Village of Pinecrest

Transition Plan

ACCESSIBILITY EVALUATION REPORT

**GENERAL ACCESSIBILITY CONSULTING SERVICES
FOR THE VILLAGE OF PINECREST, FLORIDA
RE: ACCESSIBILITY EVALUATION SURVEY FOR THE
VILLAGE OF PINECREST - PINECREST GARDENS, PINECREST, FLORIDA
PROJECT NO 10116.00**

Fig 5
Forward Reach

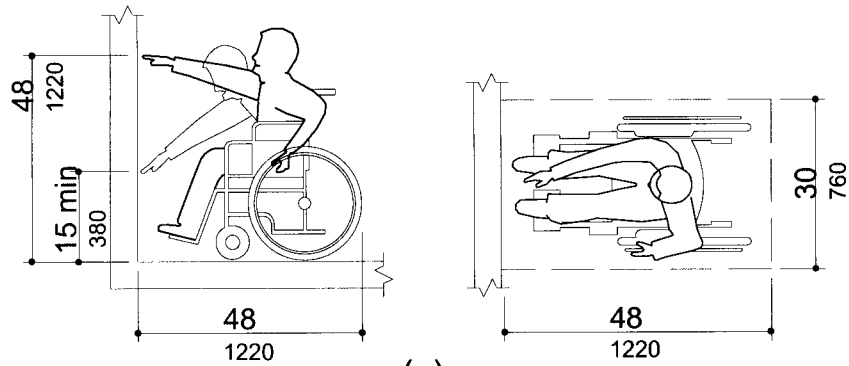
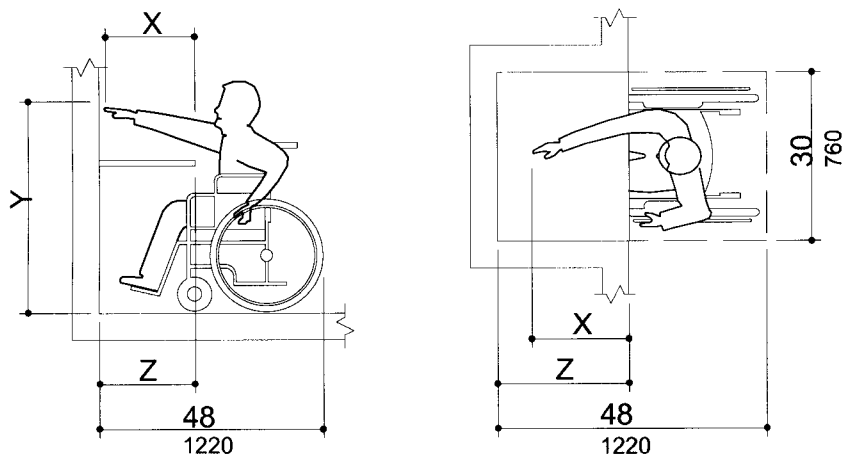
15.	Thermostat In Hibiscus Room – West Wall	The thermostat on the west wall is at a height of 60 inches above the floor to the controls.	4.27.3 Figure 5 or 6	EXCEPTION: These requirements do not apply where the use of special equipment dictates otherwise or where electrical and communications systems receptacles are not normally intended for use by building occupants.	0504 0505 0507 0508

16.	Alarm System Hibiscus Room – East Wall	On the east wall there is an alarm system. The control is at 62 inches above the floor.	4.27.3 Figure 5 or 6	EXCEPTION: These requirements do not apply where the use of special equipment dictates otherwise or where electrical and communications systems receptacles are not normally intended for use by building occupants.	0509

Fig 8
Protruding Objects

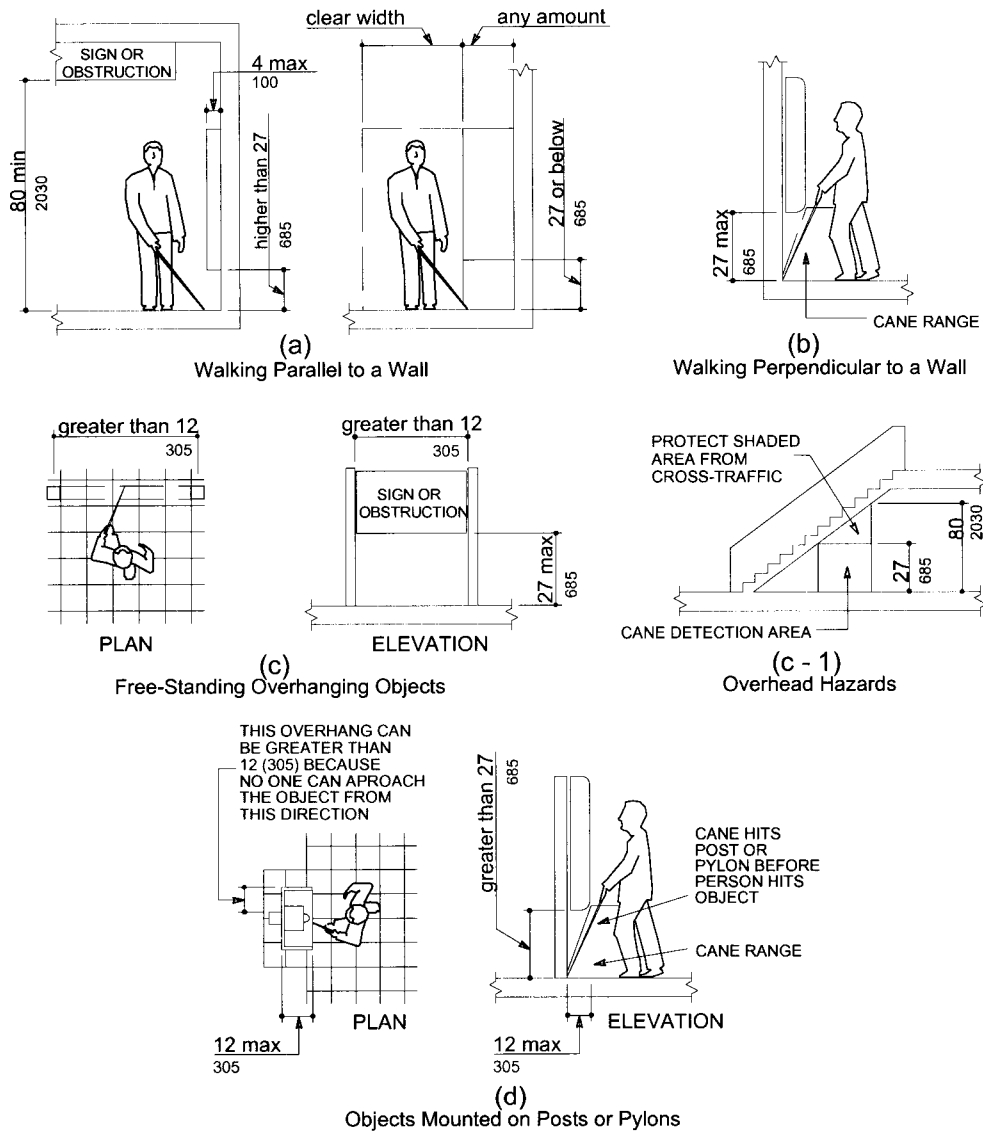
21.	Signage At The Entrance At Pinecrest Gardens	The signage at the entrance is at a height of 79 inches of the floor; the minimum required is 80 inches above the floor.	4.4.2 Figure 8(b)	Raise the signage at the entrance at Pinecrest Gardens to a minimum of 80 inches from the floor to prevent a visual impaired person from walking into it and hitting their head.	0526 0527

39.	Fan On West Side – Protruding Object	On the west side there is a fan that is 77 inches above the floor to the bottom of the unit. The fan protrudes out a distance greater than four inches.	4.4.2 Figure 8(b)	Modify the object to provide a minimum of 80 inches above the floor or provide a barrier to prevent a vision impaired person from walking into the unit such as a potted plant or trash receptacle. Consider adjusting the fan upward.	0648 0649 0650

Fig 17
Examples of Edge Protection and Handrail Extensions

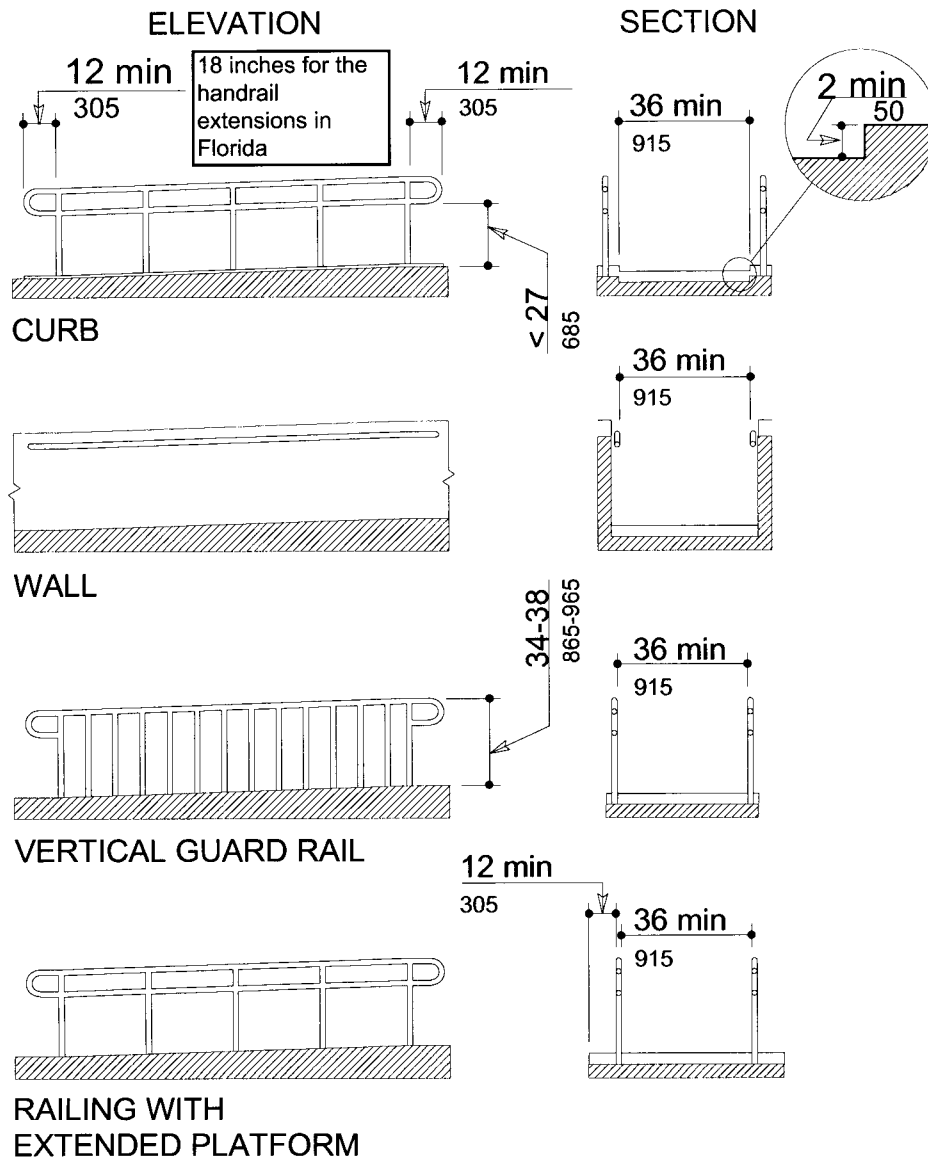
61.	Access To The Playground Equipment	The access then from the lower section overviews the playground area which can be accessible from the west side via the ramp at that area.	4.8.5 Figure 17	Provide handrails on both sides of the ramp to comply with Figure 17: handrails shall extend at least 18 inches beyond the top and bottom of the ramp segment and shall be parallel with the floor or ground surface. The clear space between the handrails and the wall shall be 1½ inch. The top of handrails gripping surfaces shall be mounted between 34 and 38 inches above the ramp surface. The gripping surface shall be continuous.	0728 0793 0794

Fig 45
Minimum Clearances for Seating and Tables

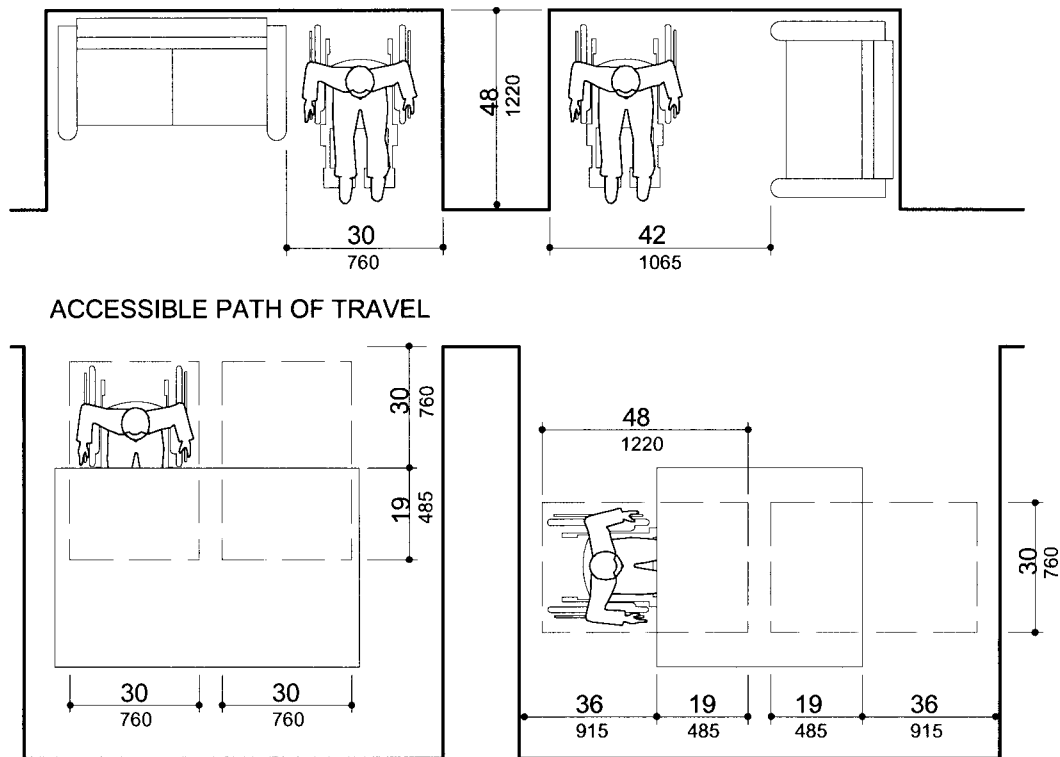
57.	Tables And Benches – North Section	North section of the seating has ten tables with four umbrellas.	4.32.3 Figure 45 4.32.4	Provide an accessible table with the knee clearance being a minimum of 27 inches high, a minimum of 30 inches wide, and a minimum of 19 inches deep to comply with Figure 45. The height of the accessible table shall be from 28 inches to 34 inches above the floor.	0714 0715 0716 0719 0720 0721 0722 0723 0724

75.	Three Tables By The Counter For The Splash And Play Area	At this area there are three tables that are provided in the landscape area. Recommend providing an accessible table at this area.	4.32.3 Figure 45 4.32.4	Provide an accessible table with the knee clearance being a minimum of 27 inches high, a minimum of 30 inches wide, and a minimum of 19 inches deep to comply with Figure 45. The height of the accessible table shall be from 28 inches to 34 inches above the floor.	0809 0810
